# SERVICE BULLETIN

Service Bulletin No.: DA20-77-02, Rev.1

Title: Electric Tachometer

3. General: This service bulletin addresses the modifications required to install an electric tachometer in place of the current mechanical tachometer. In order to complete this service bulletin, aircraft with hourmeters must have service bulletin No. DA20-79-01, 'Remote Mounting of Oil Pressure Transducer', incorporated.

FIGURE 1

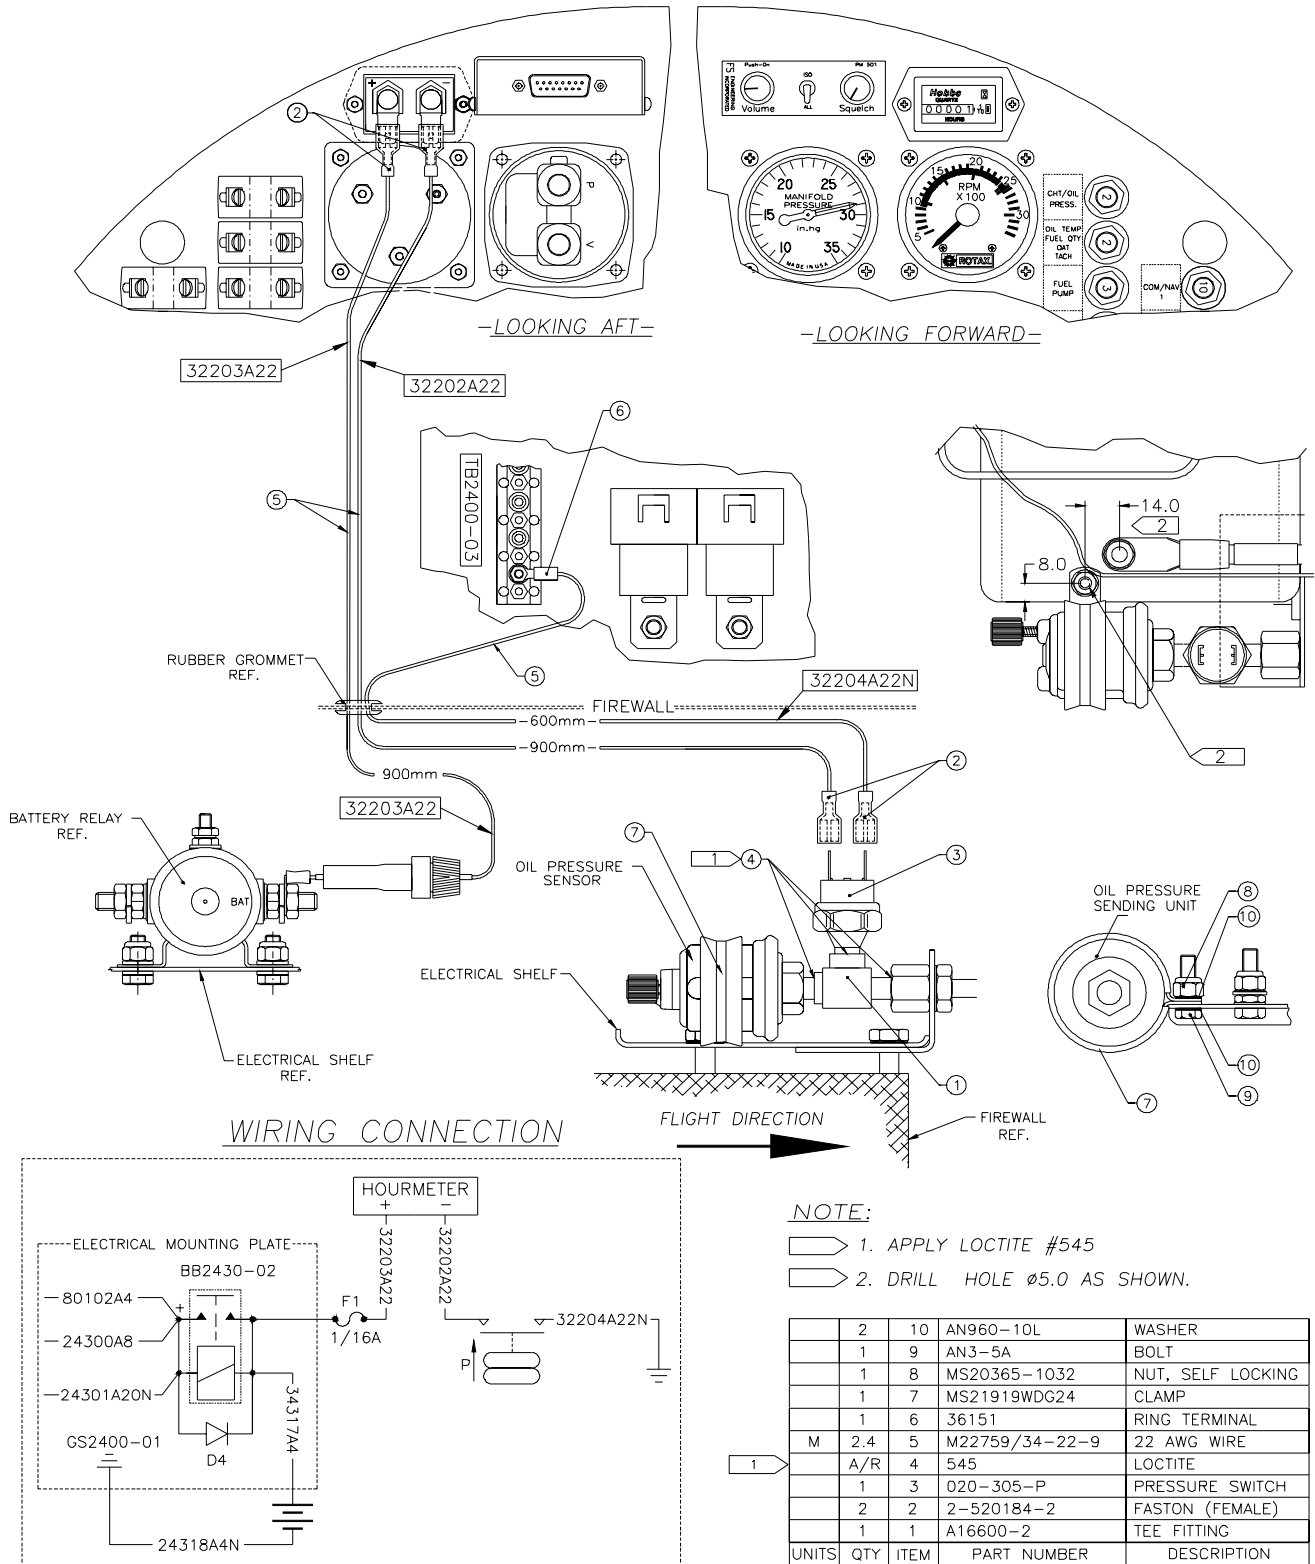
- 10.22 Refer to figure 1, note 2. Locate and drill a 3/16" (5.0mm) hole in the electrical shelf.
- 10.23 Apply Loctite 545 to the male thread on the tee fitting and connect to the bulkhead fitting.

- 10.30 Connect wire # 32202A22 to the (-) terminal of the hour meter.
- 10.31 Connect wire # 32204A22N to TB2400-03 as shown in figure 1.
- 10.32 Attach wire # 77207A22 to the load side of the circuit breaker marked 'Tach.' and attach the other end to the (+) terminal of the new tachometer.

- 10.36 Route wire # 77209A22 through the firewall to the engine trigger coil connector shown in figure 1. Install the pin on the white wire to pin 1 of the supplied connector. Install the pin with the blue wire into pin 2 of the supplied connector. Install the connector labels, refer to the wiring schematic in figure 2.

FIGURE 2

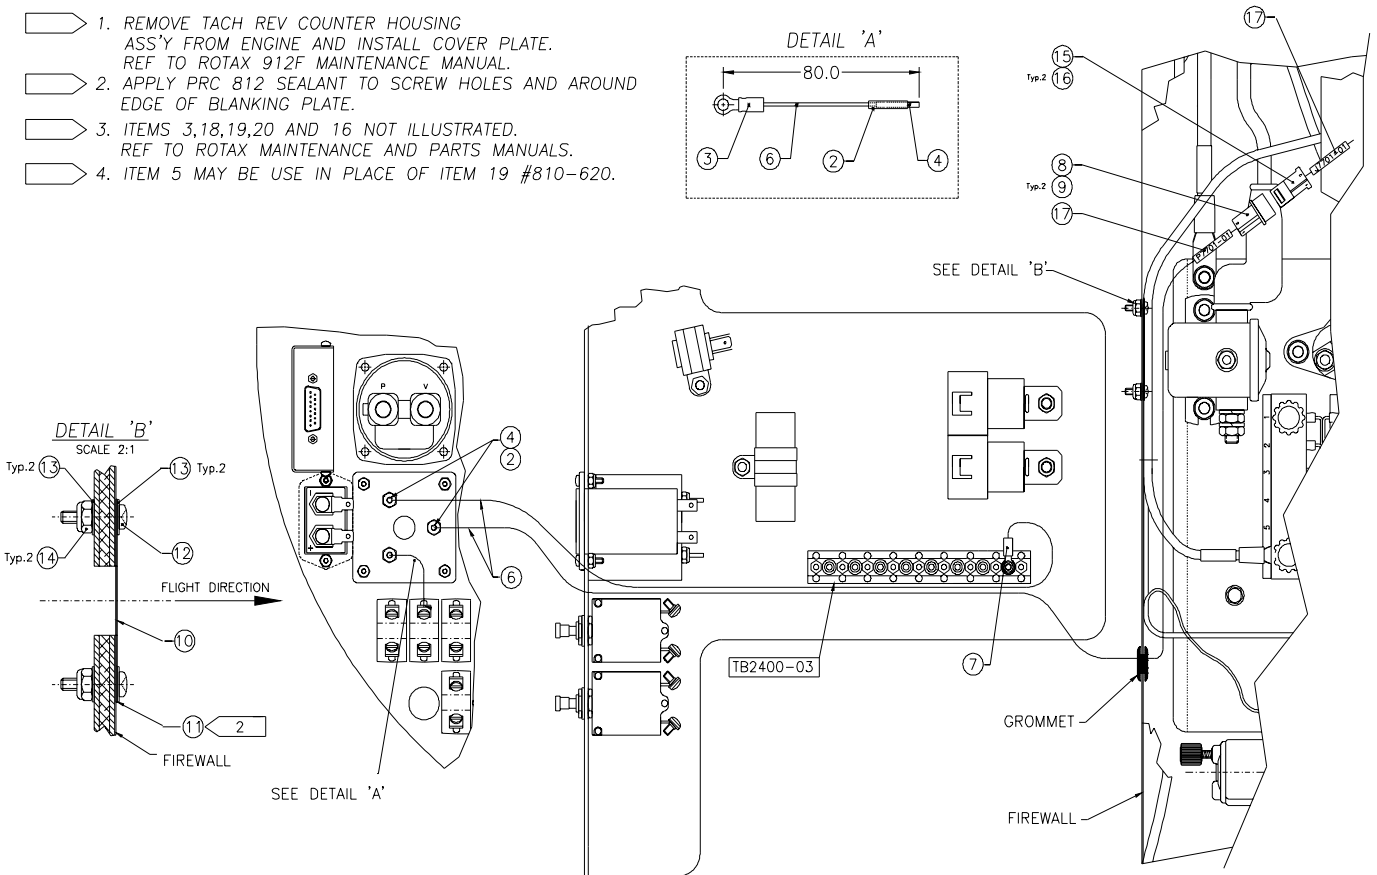
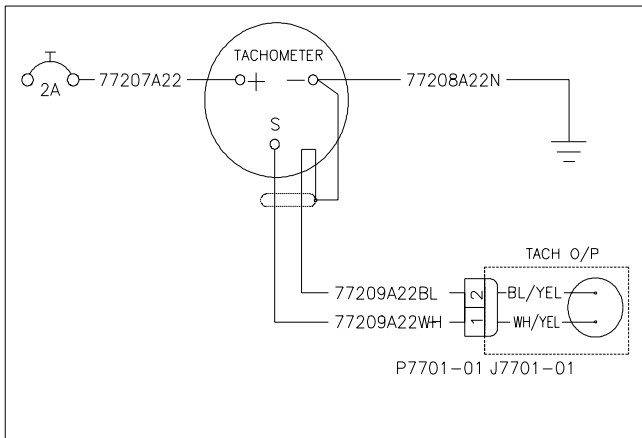
1. REMOVE TACH REV COUNTER HOUSING ASS'Y FROM ENGINE AND INSTALL COVER PLATE. REF TO ROTAX 912F MAINTENANCE MANUAL.
2. APPLY PRC 812 SEALANT TO SCREW HOLES AND AROUND EDGE OF BLANKING PLATE.
3. ITEMS 3,18,19,20 AND 16 NOT ILLUSTRATED. REF TO ROTAX MAINTENANCE AND PARTS MANUALS.
4. ITEM 5 MAY BE USE IN PLACE OF ITEM 19 #810-620.

- 10.35 Route wire # 77209A22 and 77208A22N along the existing wire route toward the firewall. Connect wire # 77208A22N to terminal block TB 2400-03 and connect to the location shown in figure 2.
